UNITED STATES PATENT AND TRADEMARK OFFICE

APPLICATION NO.	FILING DATE	FIRST NAMED INVENTOR	ATTORNEY DOCKET NO.	CONFIRMATION NO.
10/635,249	08/06/2003	Donald C. Roe	8556C	9458

Office Action Summary

DETAILED ACTION

**FIG. 3**

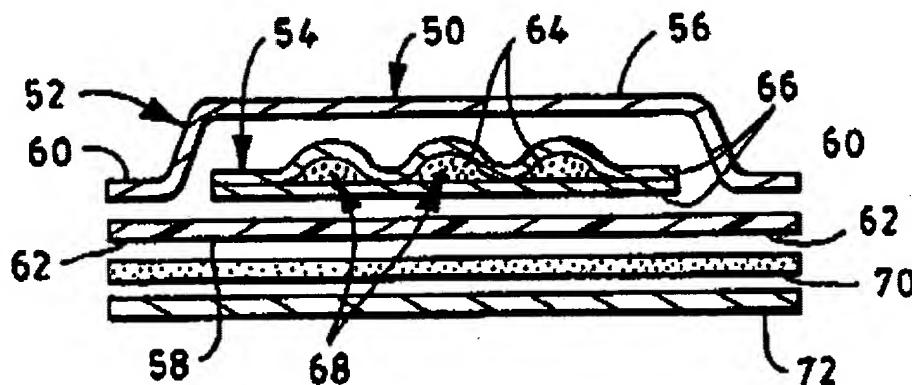
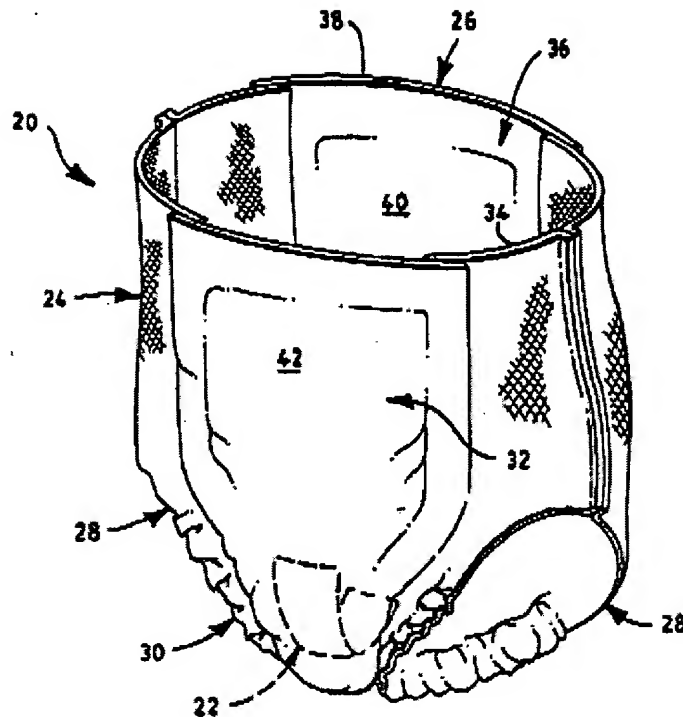
Regarding claim 7, Glaug teaches a disposable diaper (24) having a longitudinal axis, a first waist region (26), a second waist region (26), and a crotch region (30) interposed therebetween, the disposable diaper (24) comprising:

a temperature change element (22, 54) disposed on an inner surface (40), the temperature change element (54) including a permeable layer (56, 66), an impermeable layer (58) disposed opposite the permeable layer (56, 66), and a temperature change substance (64) interposed therebetween, wherein urine deposited onto the temperature change element can penetrate through the permeable layer (56, 66) in a z direction to the impermeable layer (58) and wherein the impermeable layer (58) prevents urine from passing completely through the temperature change element (54) in the z direction and supports the movement of urine in an x-y plane to wet the temperature change substance (64)(col. 7, lines 16-59; col. 8, lines 21-36)(see figures 1 & 3, infra).

Regarding claim 12, Glaug *et al.* teach that the temperature change element (22, 50) comprises a multiplicity of compartments (68) and the temperature change substance (64) is disposed in each of the compartments (68)(figure 3).

FIG.2

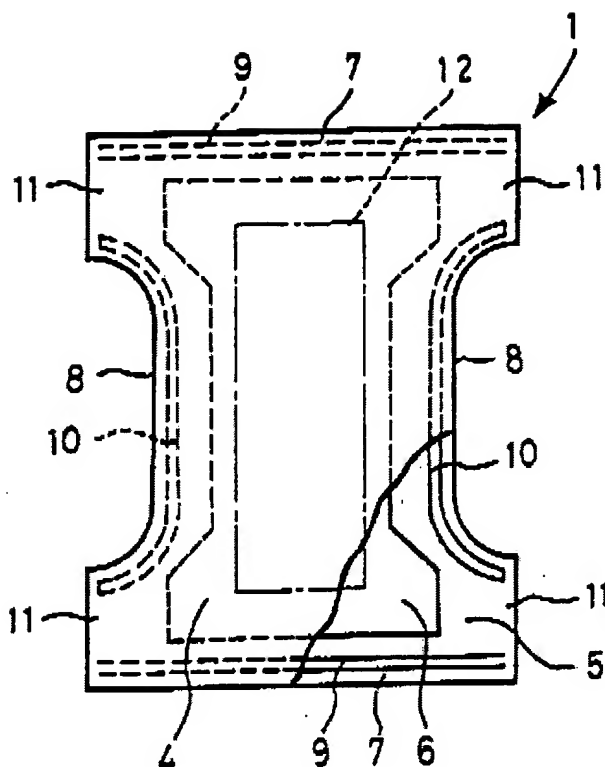
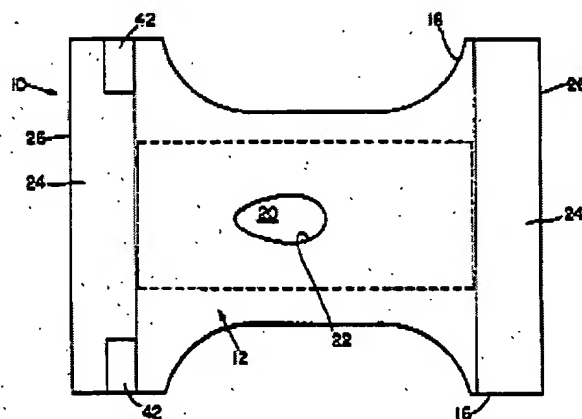
Igaue teaches a training pant (1) comprising a topsheet (4), a backsheet (5) and an absorbent core (6) therebetween (abstract)(see fig. 2, infra).

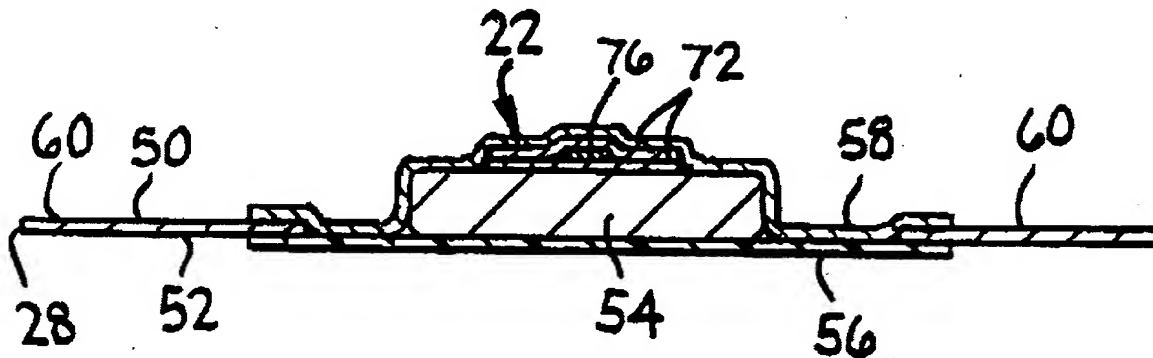
Regarding claim 10, Glaug teaches that the temperature change element is attached to the inner surface (40) of a training pant (24)(fig. 1).
